Project	<b>IEEE 802.16 Broadband Wireless Access Working Group</b> < <a href="http://ieee802.org/16">http://ieee802.org/16</a> >	
Title	<b>Comments on MS ranging and network entry in non-transparent RS systems under distributed scheduling</b>	
Date Submitted	<b>2007-09-06</b>	
Source(s)	Kanchei (Ken) Loa, Yi-Hsueh Tsai, Yung-Ting Lee, Hua-Chiang Yin, Shiann-Tsong Sheu, Youn-Tai Lee,  Institute for Information Industry 8F, No. 218, Sec. 2, Dunhua S. Rd., Taipei City 106, Taiwan  [add other co-authors here]	Voice: +886-2-27399616 Fax: +886-2-23782328 <a href="mailto:loa@iii.org.tw">loa@iii.org.tw</a>
Re:	IEEE 802.16j-07/043: "IEEE 802.16 Working Group Working Group Letter Ballot #28"	
Abstract	This contribution proposes to correct and merge the paragraphs in subclauses 6.3.9.16.2.2, 6.3.10.3.4.2.2, 6.3.10.3.4.4.2, and 6.3.10.3.4.5.	
Purpose	Text proposal for 802.16j Draft Document.	
Notice	<i>This document does not represent the agreed views of the IEEE 802.16 Working Group or any of its subgroups. It represents only the views of the participants listed in the "Source(s)" field above. It is offered as a basis for discussion. It is not binding on the contributor(s), who reserve(s) the

Figure 95i Handling CDMA ~~Initial~~ Ranging Code at ~~Non~~transparent RS

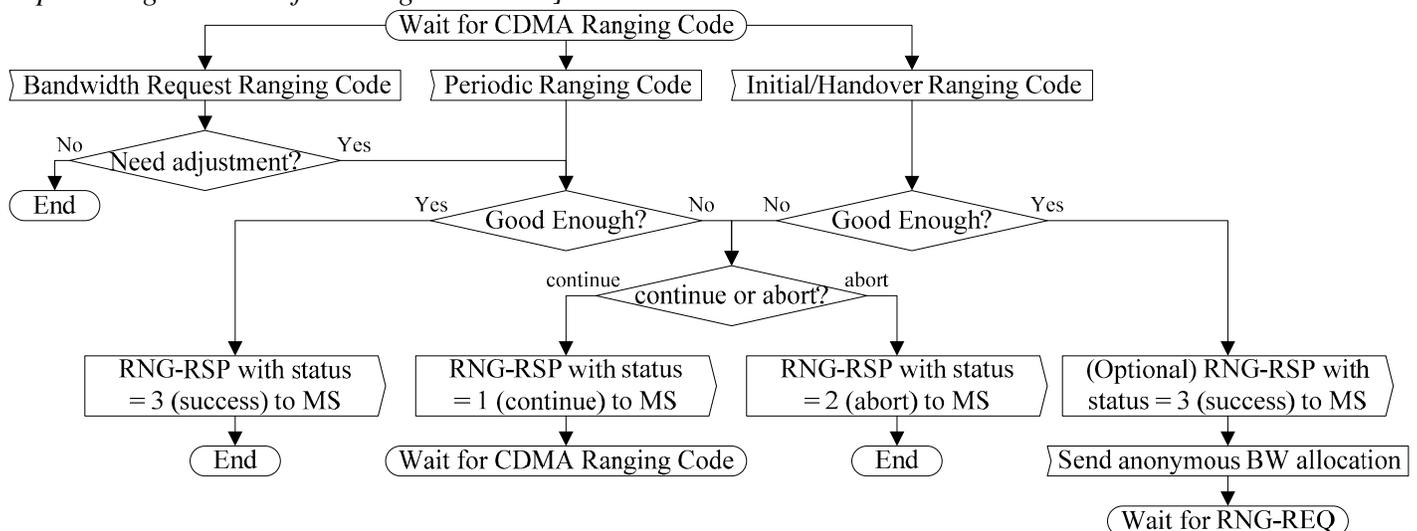
When the RS receives the initial-ranging CDMA code ~~resulting in success status that requires no corrections, it sends a RNG-RSP containing success status to the MS. And the RS shall also~~ provides bandwidth allocation to the MS with CDMA\_Allocation-IE in UL-MAP, so that the MS can send a RNG-REQ containing MS MAC Address with ~~initial~~ ranging CID. Sending the RNG-RSP message with status “Success” is optional.

[Replace Figure 95i as following indicated:]

When an RS receives the ~~CDMA-periodic~~ ranging code, the RS shall locally ~~send-broadcast~~ RNG-RSP message ~~to MS~~ on the access link. The message sequence chart in Table 201c and flow chart in Figure ~~108e~~ 95i define the periodic ranging and adjustment process that shall be followed by compliant RSs and MR-BSs.
